February 17, 2026

**RE: Response to Staff Report for Planning Board and Engineering Services Division's  
General Requirements Memorandum  
Banks Chevrolet Parking Lot Reconstruction  
234 Airport Rd, Concord, NH  
Tax Map 782, Block Z, Lot 8**

**RE: Major Site Plan Application – Revised Waiver Request  
Banks Chevrolet Parking Lot Reconstruction  
Tax Map 782Z, Lot 8  
234 Airport Road, Concord, New Hampshire**

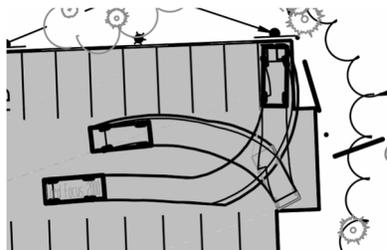
- a) Comment addressed.
- b) Comment not addressed. Place sidewalk along Old Suncook Road, pursuant to CSPR 21.02. Please address per Planning Division comments.

**Response:** The sidewalk has been added along the project frontage. A waiver request letter is enclosed requesting relief from the other portions of property frontage without sidewalk.
